Peoria Park District
Bradley Park Equipment Service Center
1314 N. Park Road
Peoria, IL 61604
Telephone: (309) 686-3386

ADDENDUM NO. ONE

PROJECT TITLE: Bike Trail Bridge
and Approaches

ISSUANCE DATE: June 28, 2013

TYP. TRUSS SECTION

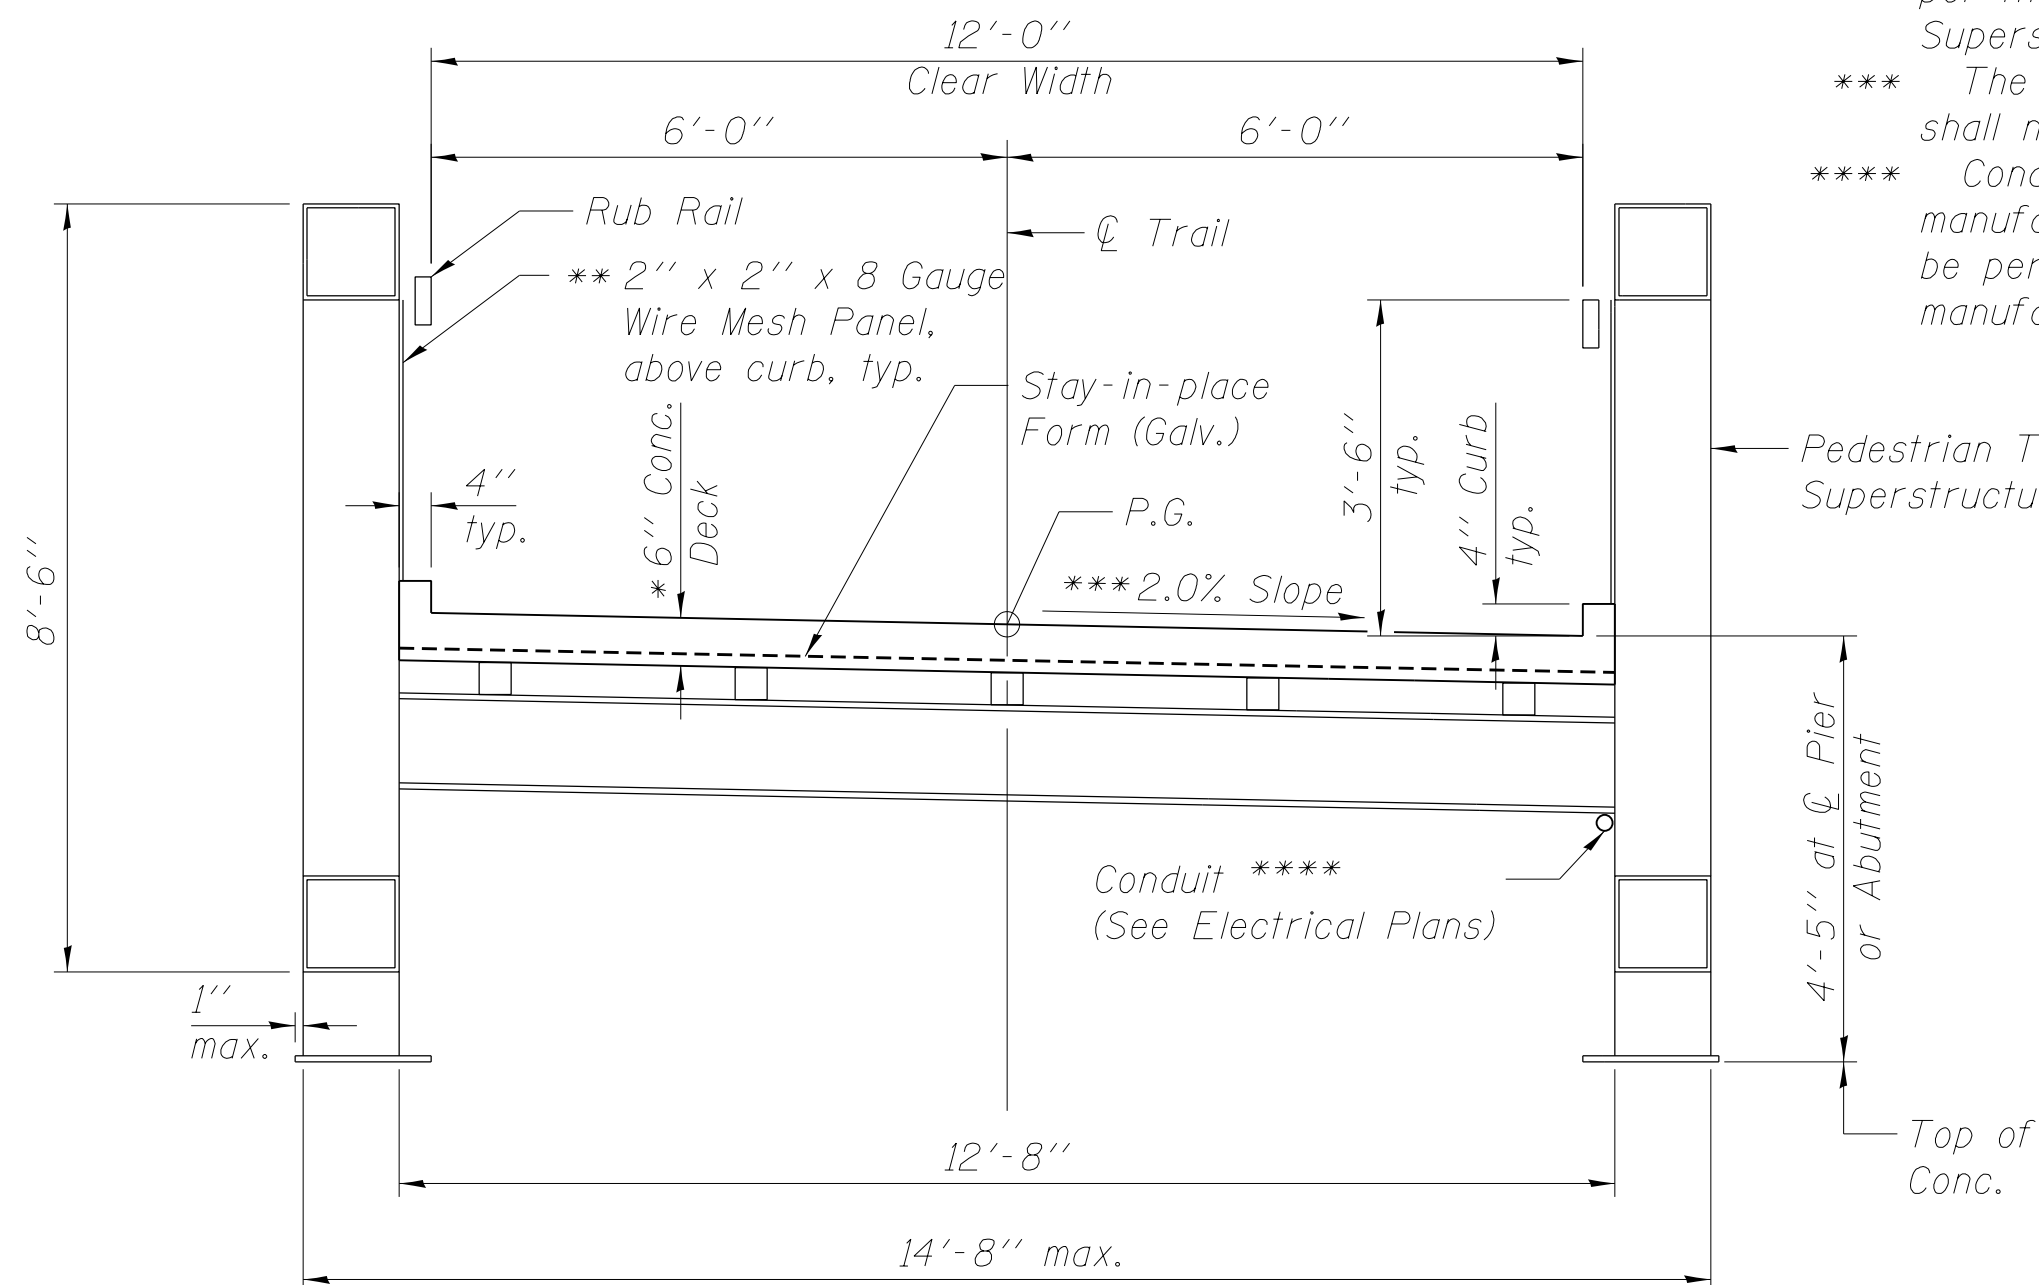
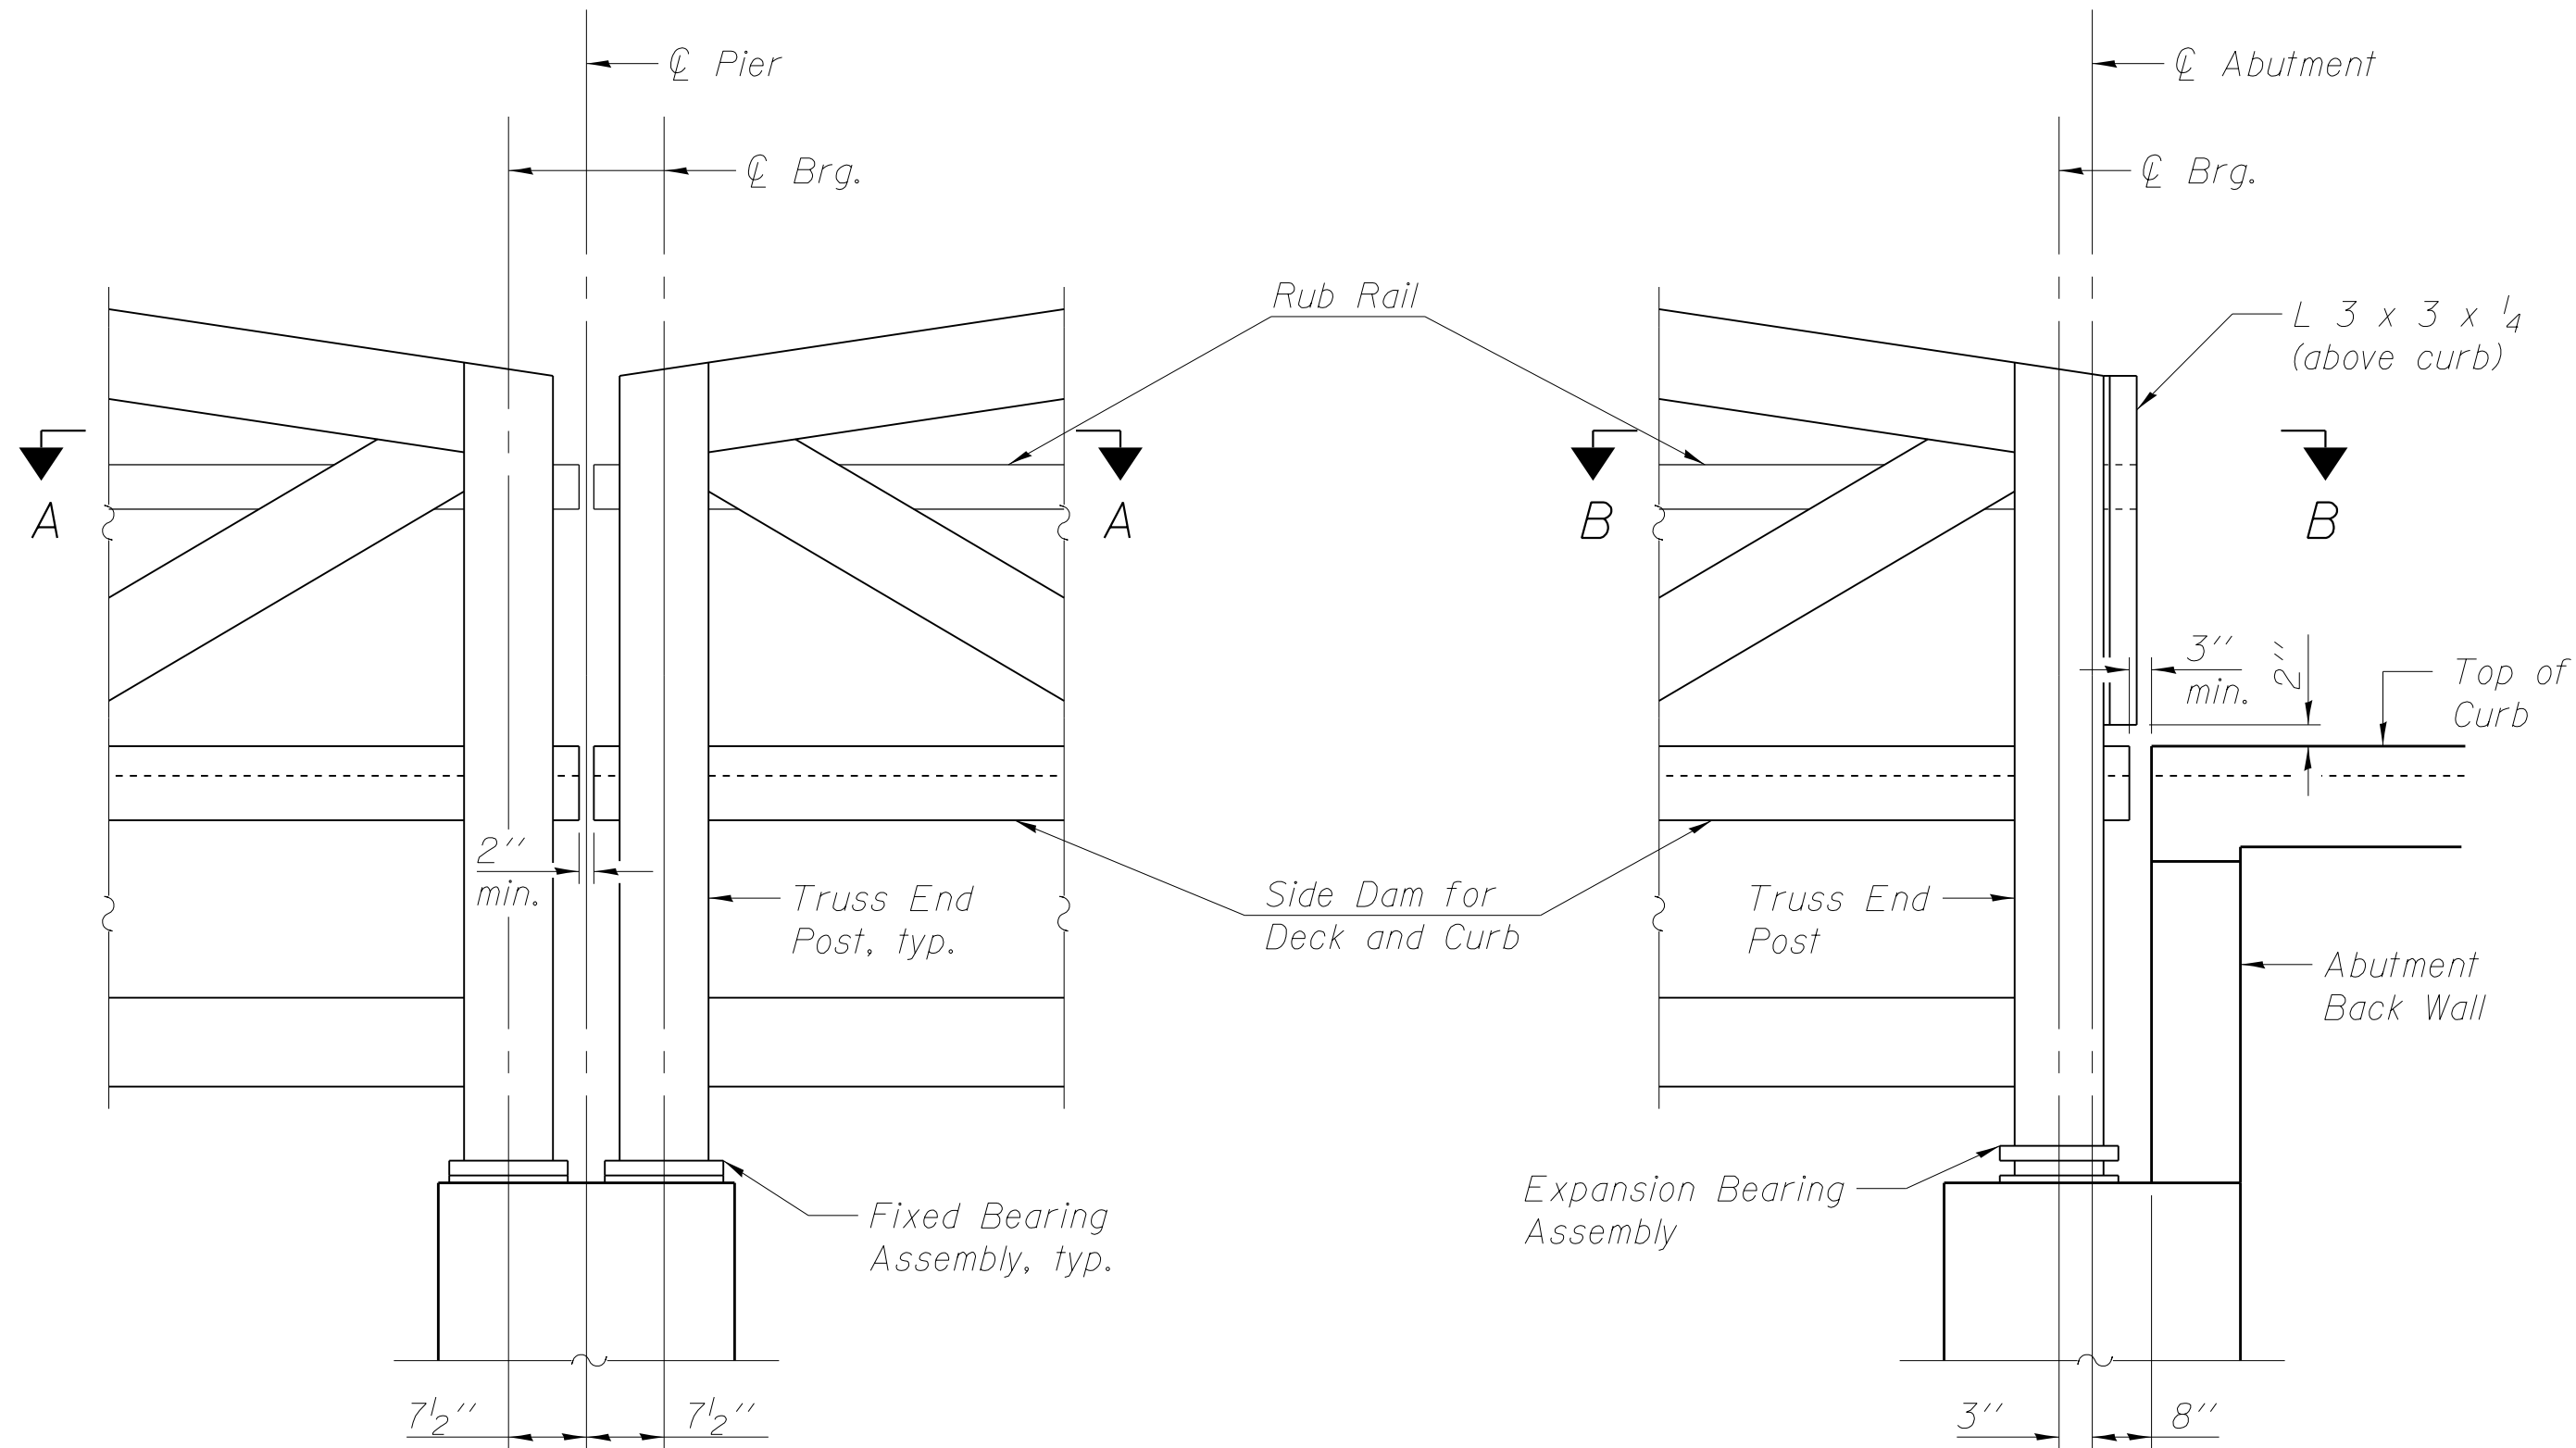
- 1. *Does the general contractor have to perform at least 50% of the work?*
No. There is no percentage of work requirement for the general contractor.
- 2. *Is there a mesh panel detail showing the panels on the inside face of the truss or placed within the verticals?*
There is no detail showing the panels. Maurer-Stutz did not want to dictate the location or the method of connection of the panels to the truss. However, we do expect a reasonable connection that does not protrude into the path that could cause a snag point for users of the bridge.

- 4. *Can the slope of the concrete deck 2% to one side of the truss be achieved by the concrete deck versus the placement of the floor beam and stringers?*
Yes, the slope of the concrete deck can be achieved by the concrete deck versus the placement of the floor beam and stringers. However, the truss must be designed for the additional dead load of the concrete deck.

- 5. *For alternate 2 can the mesh panels be powder coated vs vinyl coated?*
Yes, the mesh panels can be powder coated.

- * Concrete deck and curbs shall be reinforced per the Truss Manufacturer's design (epoxy-coated or galvanized reinforcement). The cost of deck concrete and reinforcement shall be included in Concrete Wearing Surface, 6".
- ** Wire mesh panels shall be galvanized with a continuous galvanized frame around all edges of each panel. Details and hardware for attaching the wire mesh panels to the truss shall be per the Truss Manufacturer. Cost included with Pedestrian Truss Superstructure.
- *** The cross slope of the concrete deck surface shall not be permitted to exceed 2.0%.
- **** Conduit shall be hung from the superstructure per the manufacturer's recommendation. No field welding or drilling shall be permitted unless such is reviewed and accepted by the truss manufacturer

In place of galvanized welded wire mesh panels with continuous frame, these items shall be black, vinyl-coated after being cut to size and length.
